**April 12, 2018  
Staff Report to the Southeast  
Town Design Review Committee**

**CASE #MPL2018-10011  
Item #2**

# **TYSONS CORNER II DENTIST OFFICES SPMP**

# Proposed SPMP Site Plan

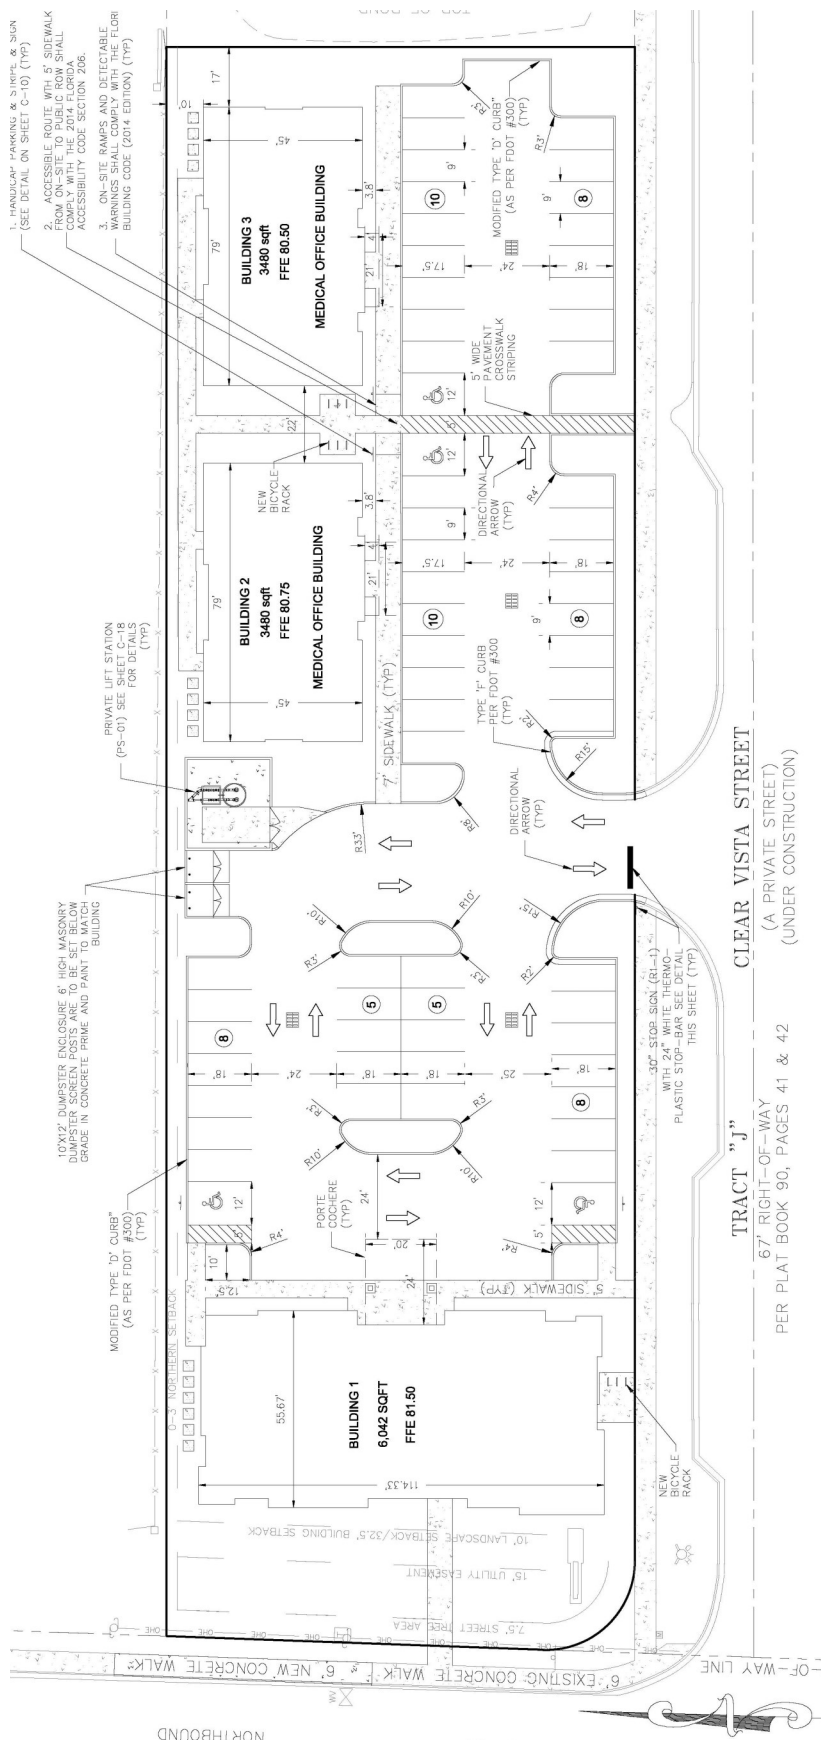
If at all possible provide a sidewalk connection from building 1 to building 2. It is encouraged the sidewalk is provided internally on the site.

# Proposed Landscape Plan

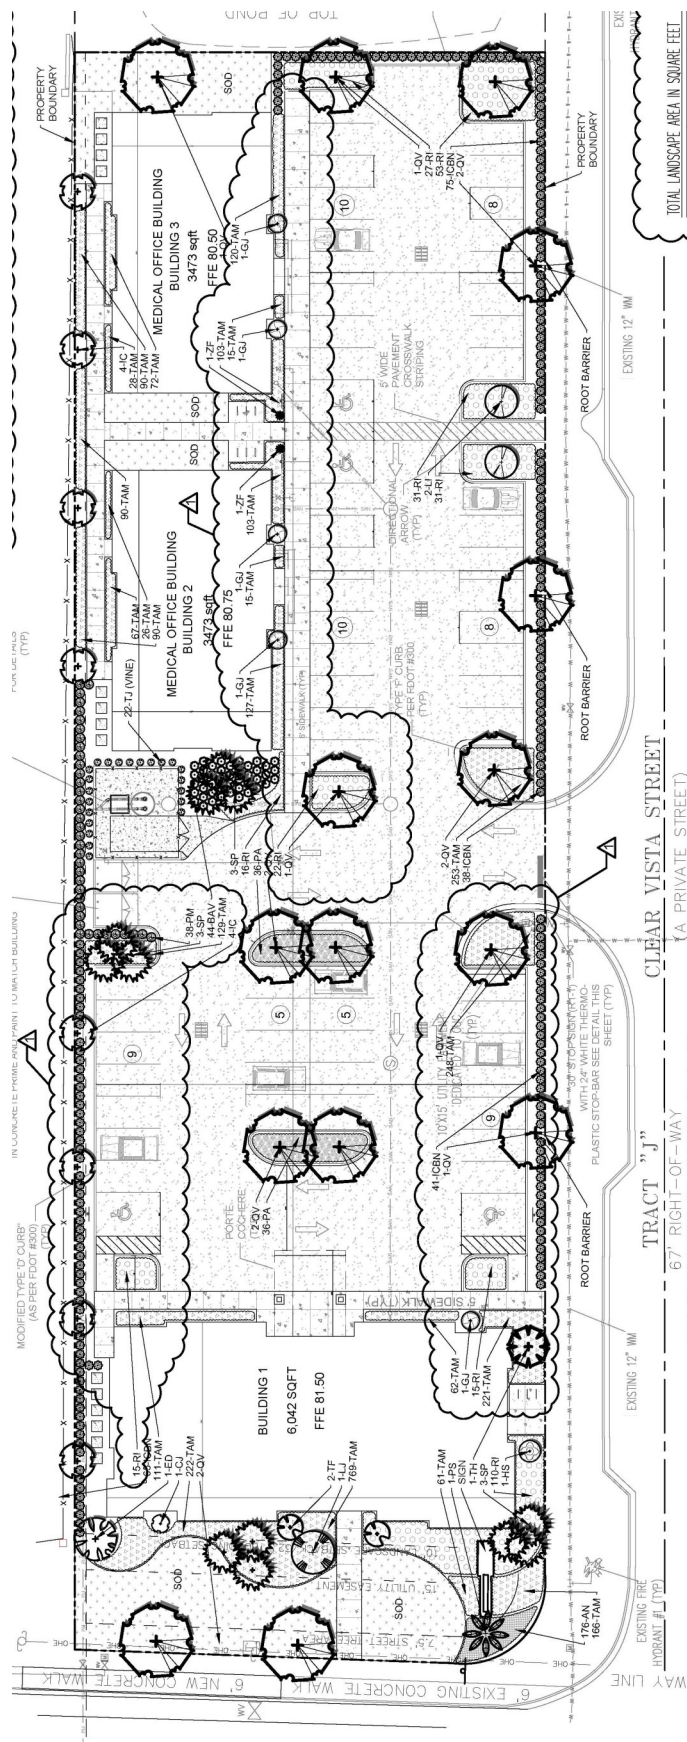
- a. Row-end landscape areas must be provided at the end of parking stalls. - 10 feet min. requirement.
- b. Street trees are required within established rights-of-way along public (Sec. 60.216. - Street Trees).

# Building Elevations, Building 1

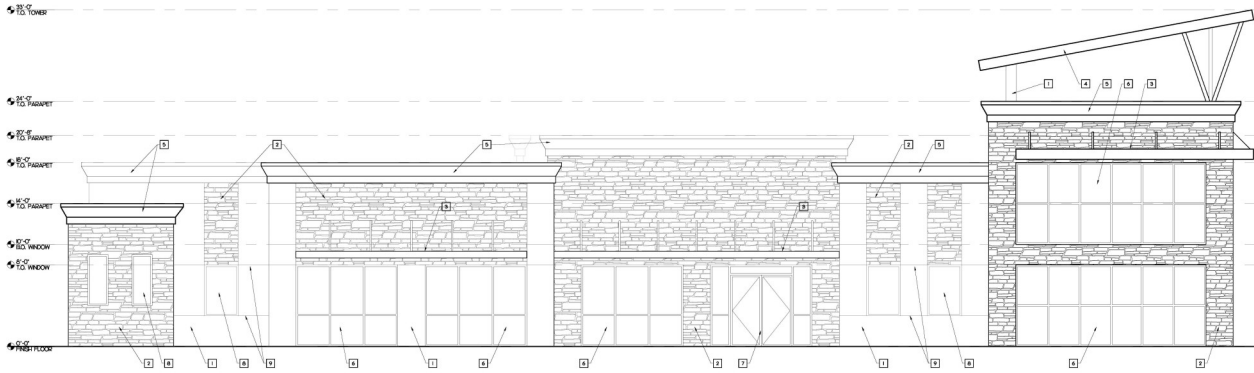
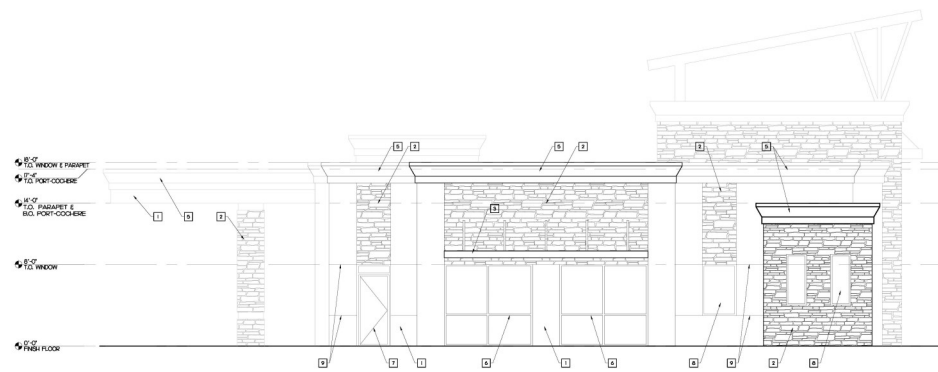
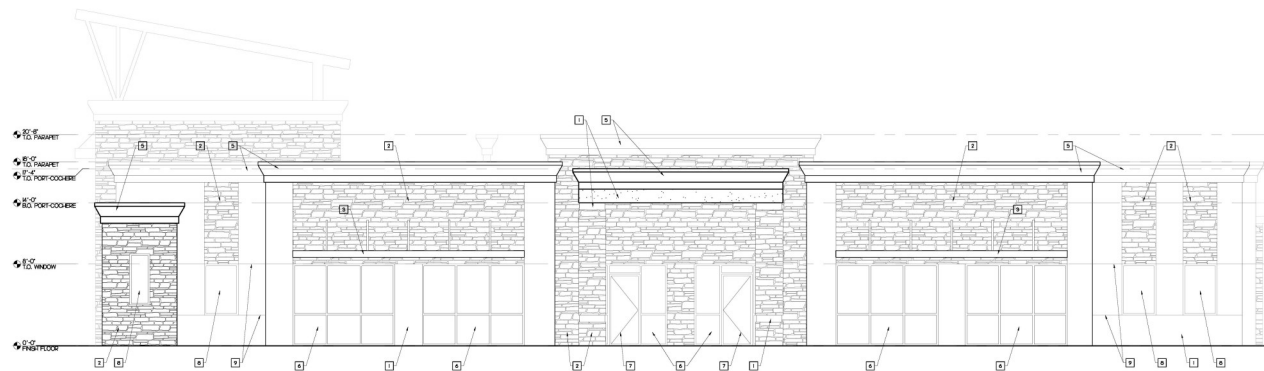
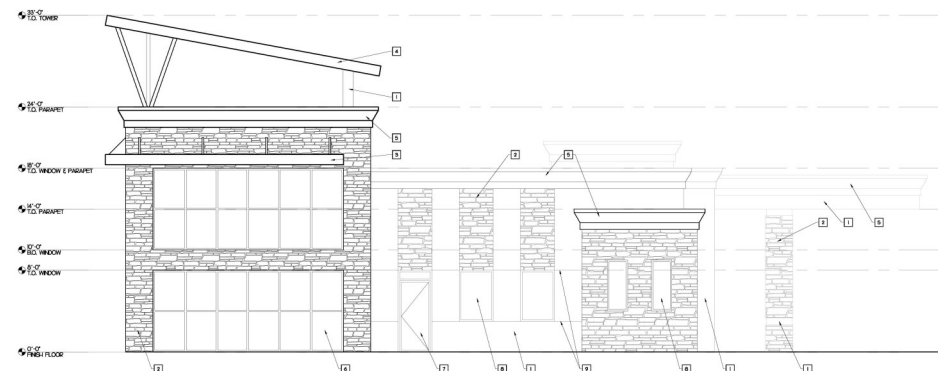
- a. The building must be finished with durable, high quality materials that are authentic to the style of architecture for which the building is proposed. All facades shall be finished with the same materials and architectural details. Side and rear building façades that are visible from a public street shall contain architectural detail comparable in appearance and complexity to the front of the building
- b. Walls spanning 20ft or more must be articulated with columns.
- c. All parapets must have a 3-d appearance and must not appear to be 2-d. Wrap parapets at a min dimension of 3-5ft.

# Proposed Dumpster Plan

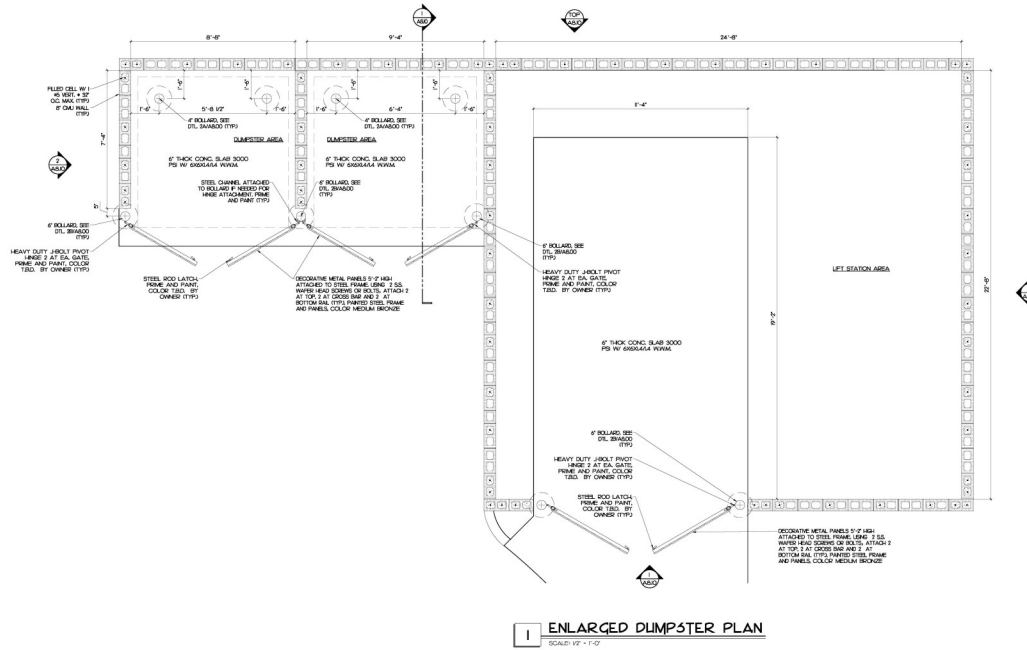
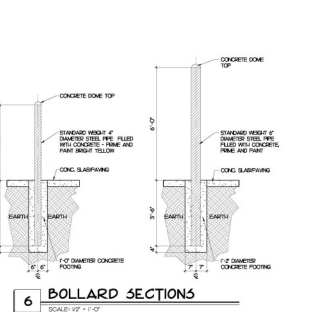
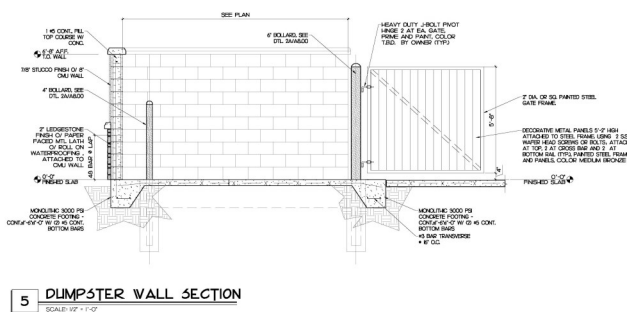
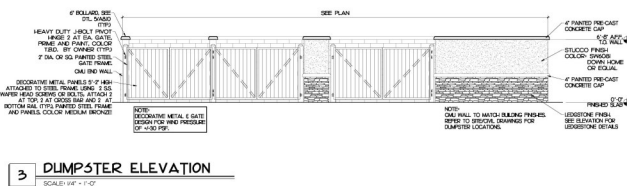
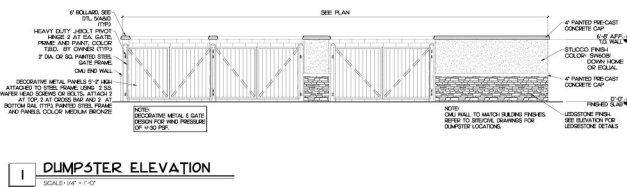
The dumpster must have a minimum opening of 12' wide and a clear depth of 10' forward of any bollards within the enclosure. Note: where dual dumpster is to be installed a minimum opening of 24' is required unless previously approved by Solid Waste.

1. Please include the City of Orlando ESM detail sheets 6 for dumpster details. Also update the dumpster dimension and location accordingly.
2. Since HDPE pipe is proposed, please submit a letter signed, dated, and notarized by the Owner/Owner's Rep stating that they shall accept the responsibilities associated with using HDPE piping on the project. In addition, they understand that if the piping is not properly installed, it may fail and would accept full responsibility and liability for any issues that may come from failure. Per the City's ESM Section 9.03.02.H, HDPE is not allowed within City ROW. The copy should be attached during the resubmittal and the original to City Hall 8th floor addressed to Liuliu Wu.
